# UNITED STATES PATENT AND TRADEMARK OFFICE

APPLICATION NO.	FILING DATE	FIRST NAMED INVENTOR	ATTORNEY DOCKET NO.	CONFIRMATION NO.
10/811,408	03/26/2004	David H. Stark	STRK-26,696	3278
25883	7590	10/17/2006		
HOWISON & ARNOTT, L.L.P P.O. BOX 741715 DALLAS, TX 75374-1715				
			EXAMINER LAZORCIK, JASON L	
			ART UNIT 1731	PAPER NUMBER

## Office Action Summary

**FIG. 2**

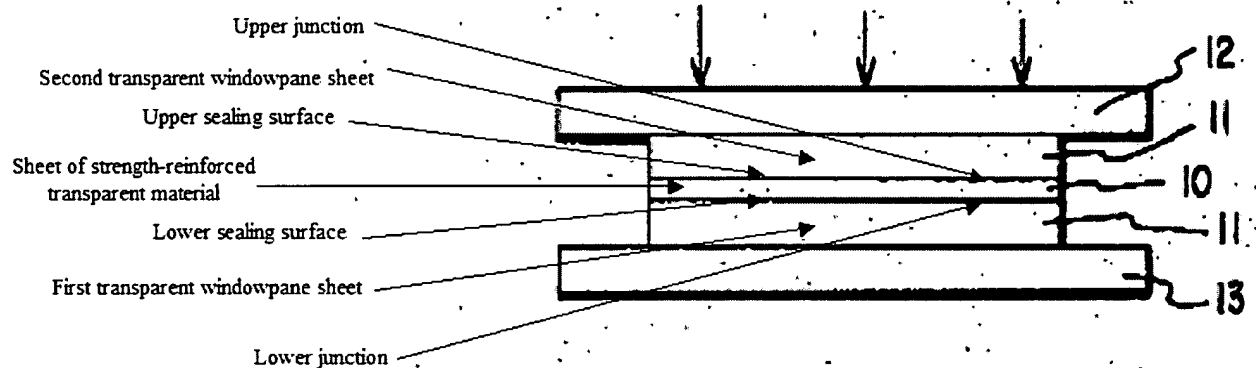
With respect to claim 1 and with particular attention to the reference figure 2 annotated to reflect the applicants chosen lexicon, Martin teaches the following;

1. Providing a sheet of devitrified glass (Column 4, Lines 41- 52) or a “sheet of strength-reinforced transparent material” with upper and lower sealing surfaces as indicated in the figure.
2. Providing first and second transparent windowpane sheets or “Pre-formed bodies of low expansion glasses” disposed in relation to the sheet of devitrified glass in such manner as to produce an upper junction and a lower junction as claimed
3. Applying a predetermined contact pressure at a predetermined temperature (column 4, lines 11-17) in order to achieve a seal or “a “diffusion bond” between the first and second transparent windowpane sheets and the devitrified sheet.

Regarding claim 14, Martin teaches that pressure is applied by inserting the assembly between platens (12) and (13) followed by applying heat by inductive means or by insertion of the apparatus into a furnace (Column 4, lines 34-40). This disclosure is read as a method wherein the step of pressing is performed before the step of heating as claimed.

With respect to Claim 16, Martin teaches that the assembly of 10 and 11 is subjected to heat and pressure to complete the seal". Where the immediate disclosure is read as providing both heat and pressure upon the assembly at the same time, said disclosure is read in the immediate claim as a process wherein the steps of pressing the windowpane sheets against the sheet of strength-reinforced material and of heating the junctions are performed simultaneously".
